Transport for NSW

# Central Precinct Western Gateway Rezoning Proposal

Response to Submissions Report

July 2020 | FINAL

Figure 7. Results around areas between Blocks A and B with 30 metre spacing between towers (Left), and with localised amelioration measures (Right)

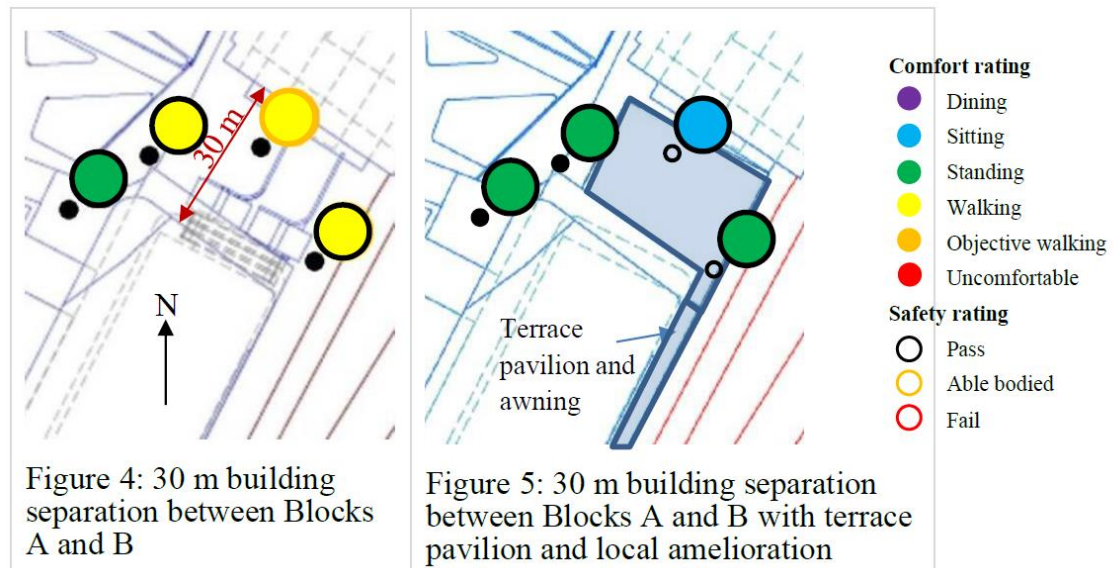
Wind conditions were modelled for the area between Blocks A and B with the results from the wind tunnel testing indicating that the proposed 30 metre separation between Block A and B towers was insufficient in its own right to meet the relevant safety criterion (refer to **Figure 7**).

However, the study found that combining the 30m building separation with the inclusion of localised amelioration measures such as a terrace pavilion between Blocks A and B, wind conditions would significantly improve and provide acceptable levels for the intended use of the space (refer to **Figure 7**). An awning along the eastern façade of Block B building combined with a Terrace Pavilion would further improve wind comfort and safety criteria in this location.

In response to this issue, the draft Design Guide for the Western Gateway has been amended to specify a minimum 30 metre separation Blocks A and B. The proponent for Block B acknowledge and support recommendation to accommodate additional building separation without the loss of GFA. The 30m has been accommodated within Block B.

Figure 8. Results around south-west corner of existing conditions (Left), with 6 m setback to Lee Street (Centre), and with 6 m setback and amended geometry (Right)

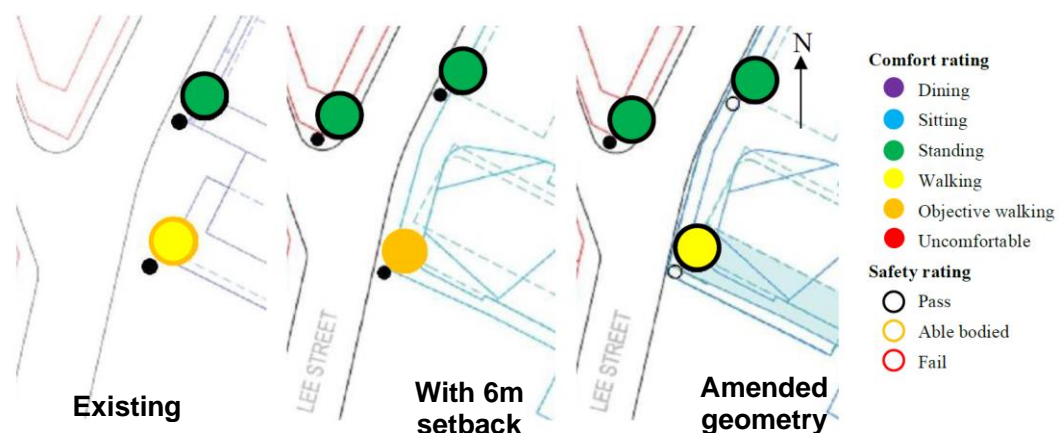
With regard to the suggested six (6) metre upper level setback from Block B podium fronting Lee Street. Wind tunnel testing undertaken by ARUP concluded that acceptable wind conditions for comfort and safety could be achieved through appropriate design and architectural interventions. It noted that the south-west corner of Block B currently experiences wind conditions that exceed the relevant safety criterion, and that the suggested 6 metre setback to Lee Street resulted in wind conditions around the south-west corner of the sub-precinct to become measurably worse.

In response to this, further testing was undertaken to identify the most effective design solution to improve wind conditions whilst maintaining the tower envelope and keeping within the envelope controls. The outcome of this testing confirmed that the most effective strategy for mitigating wind impacts along Lee Street was to block the southern colonnade of the building on Block B and wrap an awning around the buildings south-west corner to Lee Street. With these amelioration measures, the wind conditions around the south-west corner were improved to be better than the existing conditions and maintained similar conditions along Lee Street.

With the above in mind, further testing undertaken by ARUP confirms that the most effective solution to improve wind conditions whilst maintaining the tower envelope and keeping within the envelope controls, is to block the southern colonnade of the building on Block B and wrap an awning around the south-west corner. With these amelioration measures, the wind conditions around the south-west corner were improved to be better than the existing conditions and maintained similar conditions along Lee Street (refer to **Figure 8**).

Figure 9. Existing wind conditions compared to results around cumulative wind assessment with Blocks A and B

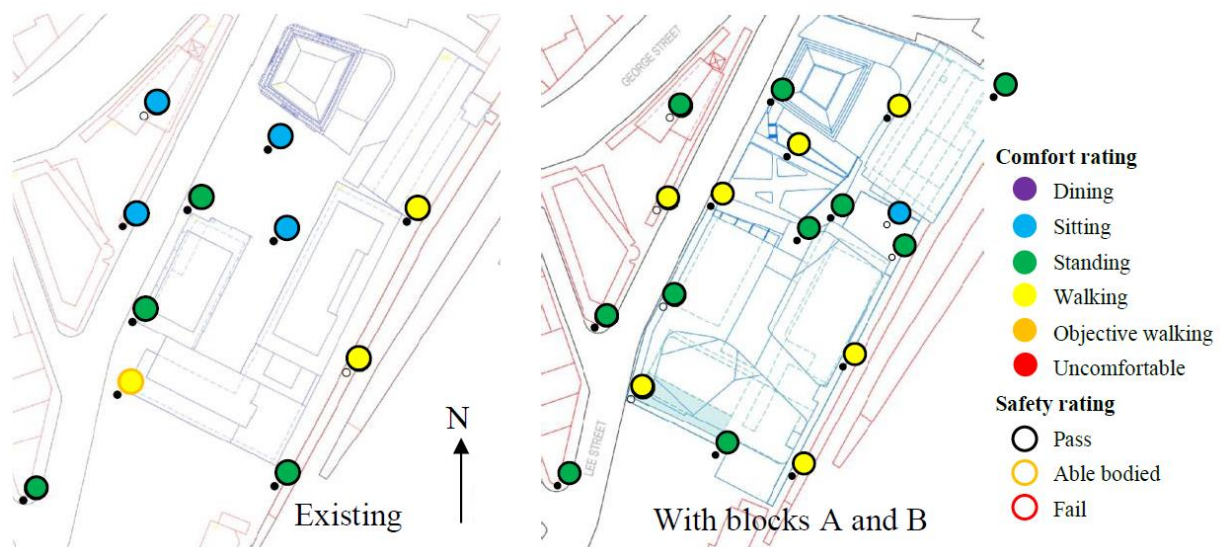
Further detailed cumulative wind testing under a developed scenario for Blocks A and B was undertaken of the proposal in response to the matters raised by the City of Sydney and the Project Review Panel, and confirmed that:

Overall, the cumulative impacts of Block A and Block B developments have been assessed and can meet appropriate wind comfort and safety conditions for the intended use of the spaces, without reliance on temporary structures to mitigate wind impacts. Architectural interventions (at DA stage) provide the greatest form of mitigation and ability to achieve acceptable wind comfort and safety criteria for the intended purpose.

A cumulative wind analysis of Blocks A and B has been undertaken by both proponents and confirms that acceptable wind conditions can be achieved within and around the sub-precinct that is consistent with a CBD scaled environment. As shown in **Figure 9**, wind testing confirms that comfort ratings can be achieved that support walking through to sitting within and around the sub-precinct. Inevitably, wind conditions will change due to the proposed Western Gateway sub-precinct, but importantly the cumulative wind assessment confirms that all areas within and surrounding the sub-precinct achieve safety ratings that pass the relevant criteria. Importantly it is noted that both ARUP and Windtech have undertaken independent cumulative wind assessment using the same building envelope models and have arrived at generally consistent conclusions with regards to the wind effects within and surrounding the sub-precinct.
